Subject: **Docket No. 50-206, 50-361, 50-362, and 72-041**
Response to Request for Additional Information
Regarding Emergency Planning Exemption Request
San Onofre Nuclear Generating Station, Units 1, 2, 3 and ISFSI

**Response to NRC Request for Additional Information (RAI-016)
Regarding Emergency Planning Exemption Request**

RAI-016

Figure RAI-016-01

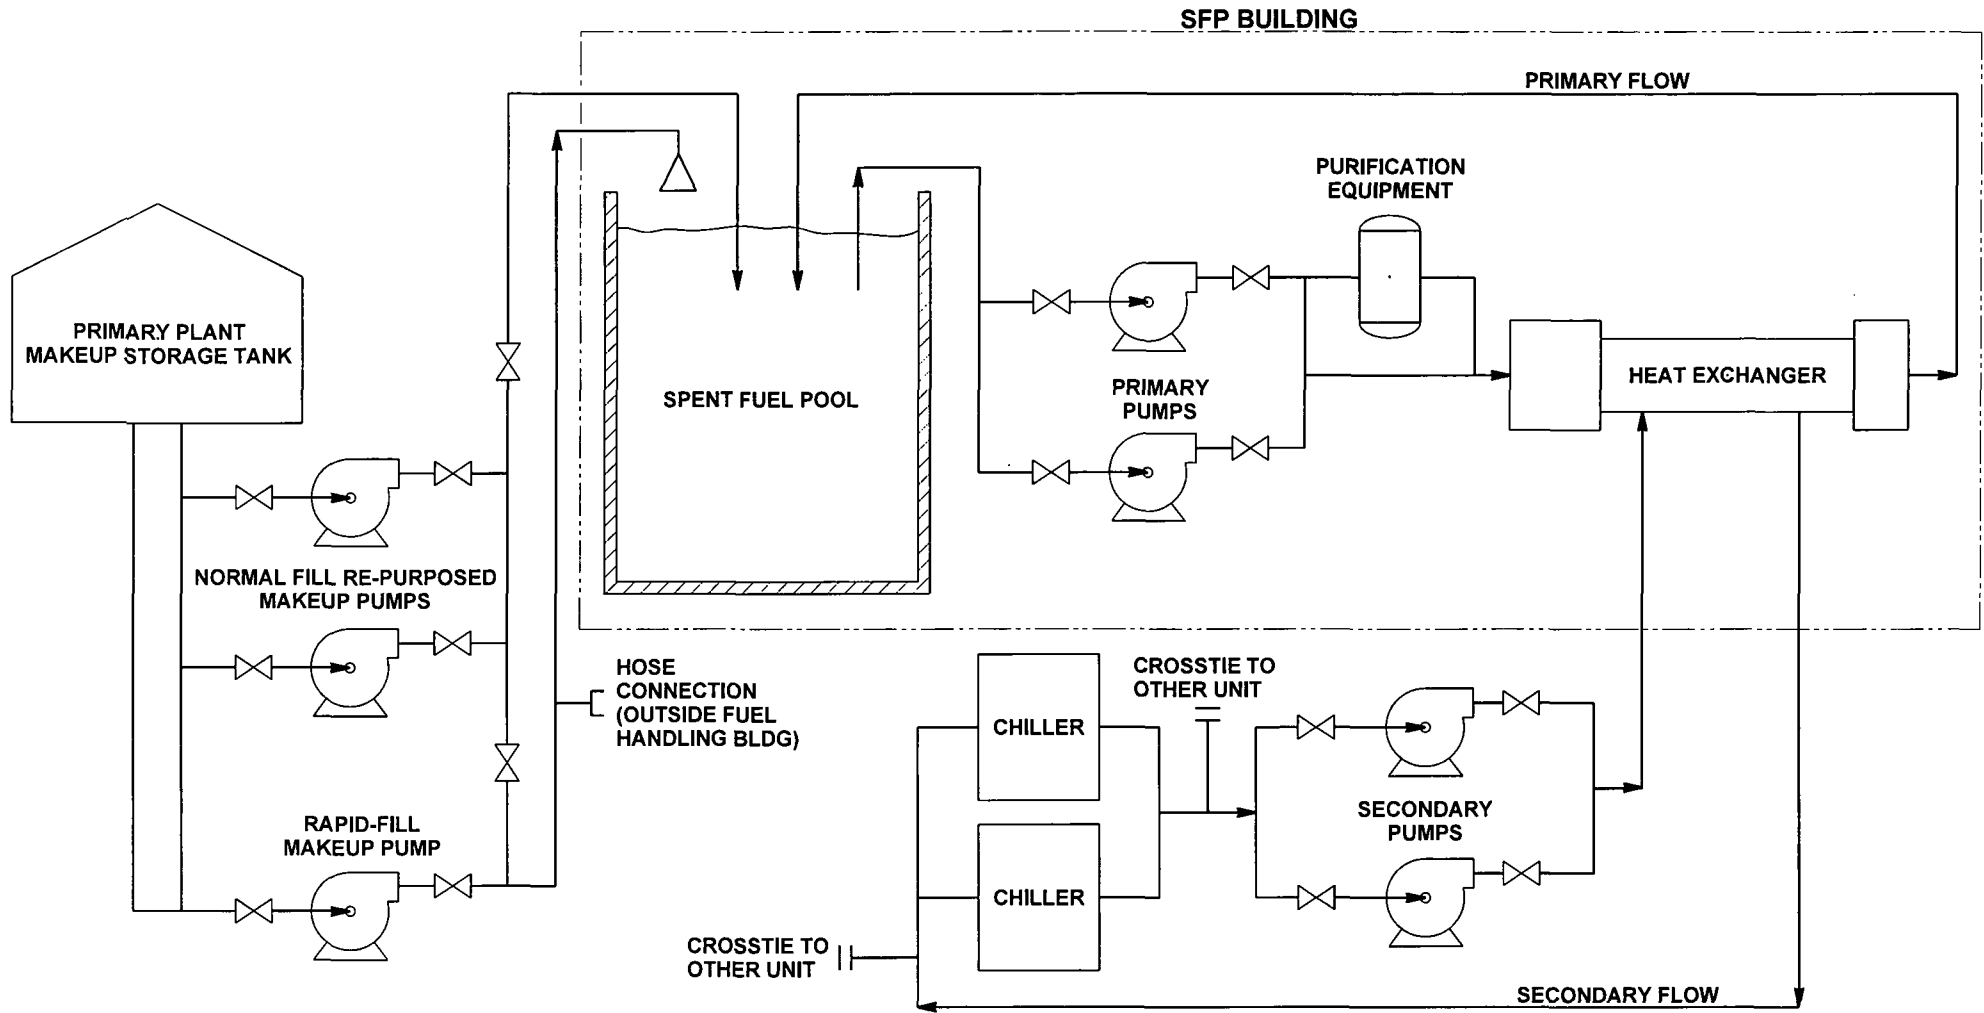
Section 9.1.3 of the SONGS Updated Final Safety Analysis Report (UFSAR), Rev. 36, described that the spent fuel pool (SFP) cooling systems consisted of redundant pumps powered from Class IE power supplies, the SFP cooling system pumps could supply makeup to the pool from the seismically-qualified refueling water storage tank to the SFP, and the safety-related shutdown cooling system could be used for SFP cooling when not required by technical specifications for core cooling. The alignment with the NUREG-1738 Staff Decommissioning Assumptions and Industry Decommissioning Commitments related to the SFP cooling system provided by letter dated September 9, 2014, suggests that the described capabilities would not be maintained while fuel remains in the SFP. Please describe the minimum design criteria with respect to redundancy and quality of the SFP normal makeup and cooling systems (including essential supporting systems) that will be maintained during decommissioning while fuel remains in the SFP.

Figure RAI-016-01 provides the functional design of the SFP Island.

The design will include one primary loop per SFP. Each primary loop includes two 100% capacity pumps and a single heat exchanger. A spare heat exchanger is available for installation on either SFP.

There will be one secondary loop per SFP. Each secondary loop will consist of two 100% capacity pumps. To provide increased reliability, the chiller units on the secondary loops include excess capacity with the ability to cross-tie between each SFP's secondary loops.

The SFP Island includes two 100% capacity primary loop pumps. One heat exchanger is available, with a spare heat exchanger available for installation in either SFP. The secondary loop provides two 100% capacity pumps and two chillers with excess capacity. Cross-tie capability is provided such that three chillers provide sufficient capability for both SFPs.

Figure RAI-016-01 provides the functional design of the SFP Decommissioning-Phase Inventory Makeup System.

Normal SFP inventory makeup will include the use of "re-purposed" existing component cooling water makeup pumps (hereafter referred to as re-purposed SFP makeup pumps). There are two re-purposed SFP makeup pumps per unit providing 18 gpm each. An additional pump will be provided for rapid-fill purposes (300 gpm or larger). All three pumps will discharge into the existing installed plant SFP Cooling Pump suction piping.

The three pumps provide redundant capability to provide makeup to the SFP. In addition, there are inter-unit cross-tie capabilities available via a hose connection.
